**SUNDRY NOTICES AND REPORTS ON WELLS**  
**Do not use this form for proposals to drill or to re-enter an abandoned well. Use Form 3160-3 (APD) for such proposals.**

8. Well Name and No.  
**AXI Apache J 21**

9. API Well No.  
**30-039-20437**

Re: Permanent Abandonment  
Well: AXI Apache J 21.

**Schematic - Proposed  
AXI APACHE J #21**

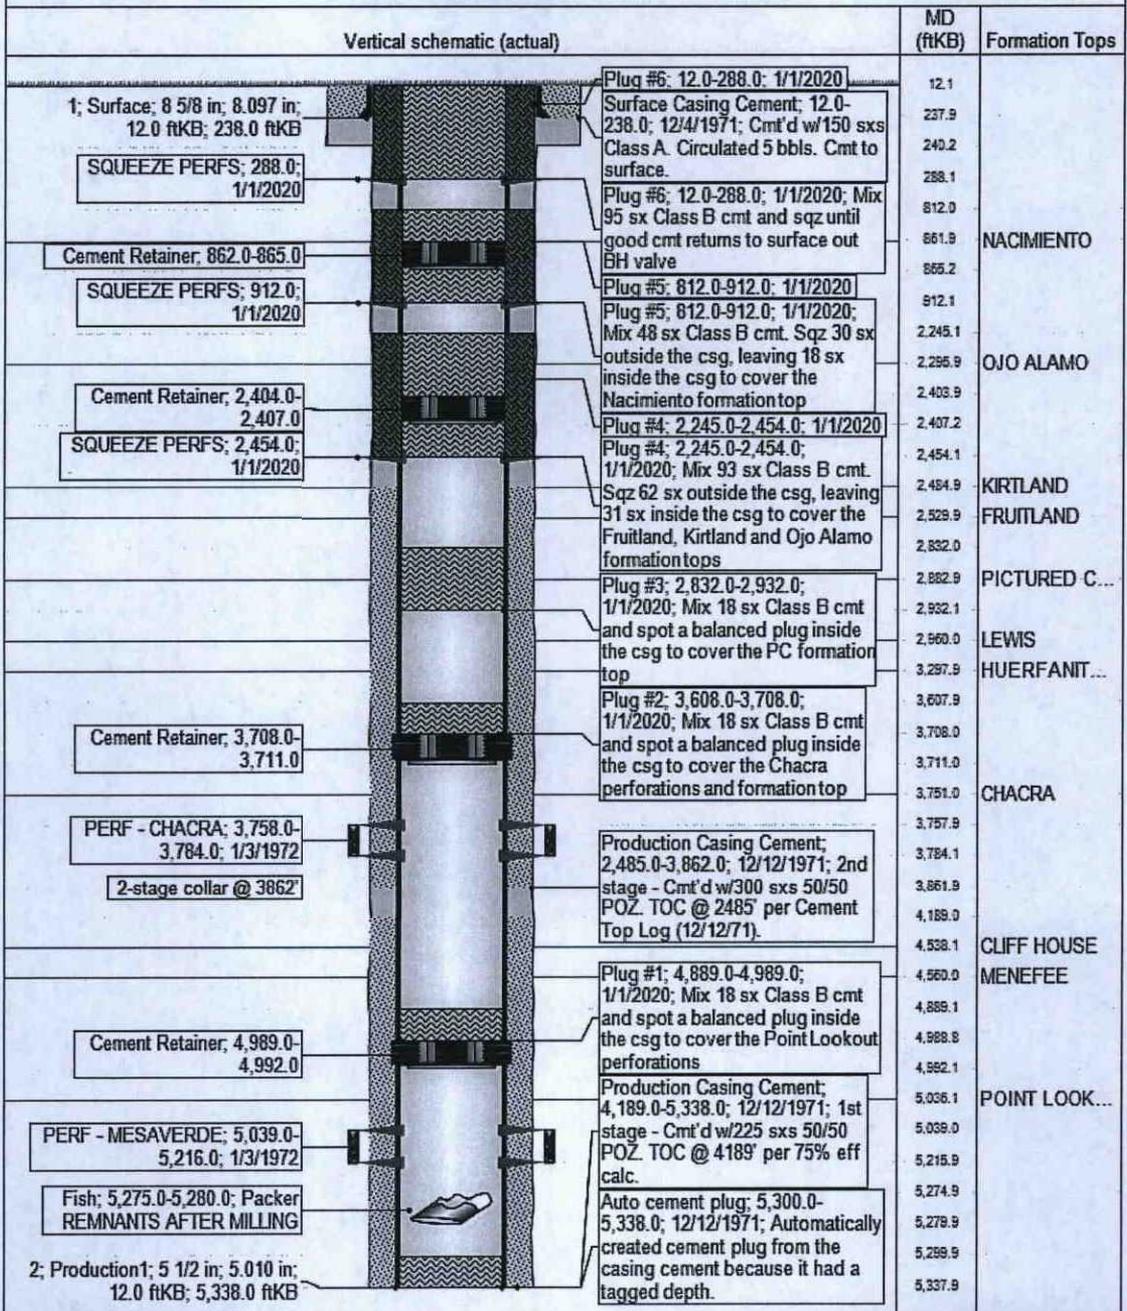
1. Plugging operations authorized are subject to the attached "General Requirements for Permanent Abandonment of Wells on Federal and Indian Lease."
2. Farmington Office is to be notified at least 24 hours before the plugging operations commence (505) 564-7750.
3. The following modifications to your plugging program are to be made:
  - a) Set a plug (4588-4488) ft. to cover Mesaverde top. BLM picks top of Cliff House at 4538 ft.
  - b) Set plug 2 (3800-3700) ft. to cover Chacra top. BLM picks top of Chacra at 3750 ft.
  - c) Set plug #4 (2741-2241) ft. inside/outside to cover the Fruitland, Kirtland and Ojo Alamo tops. BLM picks top of Ojo Alamo at 2291 ft, Fruitland at 2691 ft.
  - d) Set plug #5 (911-1011) ft. inside/outside to cover the Nacimiento top. BLM picks top of Nacimiento at 961 ft. Adjust cement volume accordingly.

You are also required to place cement excesses per 4.2 and 4.4 of the attached General Requirements.
